# Project Title: Great Wolf Lodge, Chesterton Planning review

**Ref No:** 0354-RPT-01

### Planning review

Cherwell District Council

**Figure 6.3** - Extract of water body stress classification source: Environment Agency

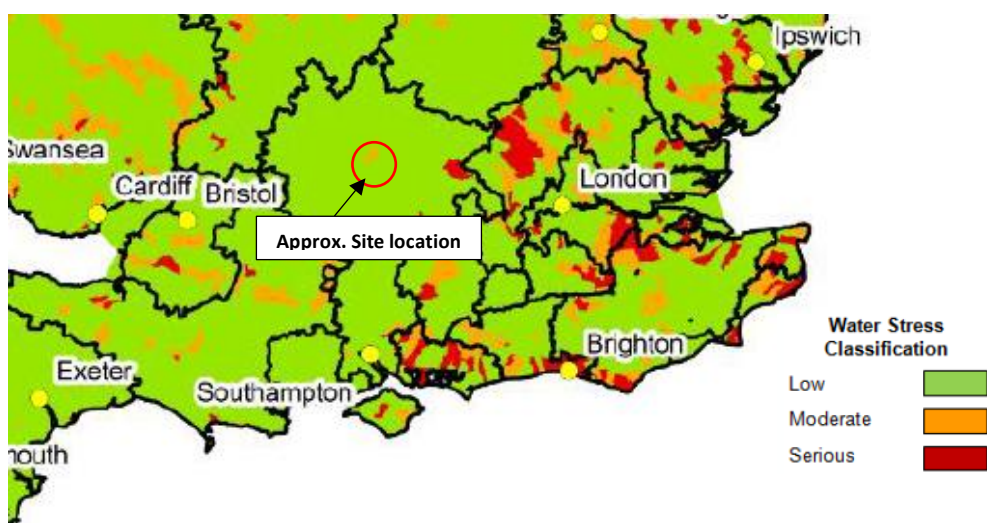
With reference to Figure, the EA's current classification of water body stress for the approximate area of the site is low/moderate. The moderate rating is considered to apply to the 'Upper Cherwell area' as noted in CDC's Local Plan. The identification of the district as an area of Serious Water Stress appears therefore based on the EA's categorisation at a 'company-wide level' to 'support decision about metering'. It is therefore not a strict classification of the Cherwell District. Confirmation of this could be sought from the EA's Cherwell Catchment officer - Stuart Malaure (stuart.malaure@environment-agency.gov.uk).

Figure 6.4 – Location of BGS recorded abstraction wells

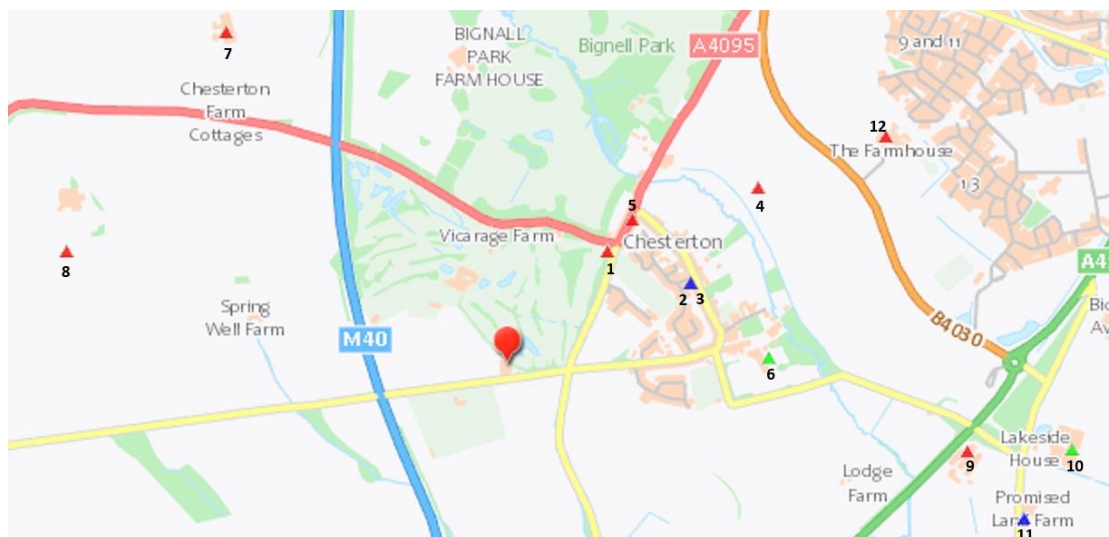
Based on the above we would consider that groundwater abstraction on the site may be a viable means of reducing reliance of mains water supply to the development. Current EA abstraction licensing exempts abstractions of less than 20 cubic metre per day although greater volumes may be extracted subject to permitting.

The site geology and permeability of groundwater-bearing strata will dictate the viability of abstraction. We would advise that CDC seek assurance from the applicant that such opportunity has been explored and adequately assessed.
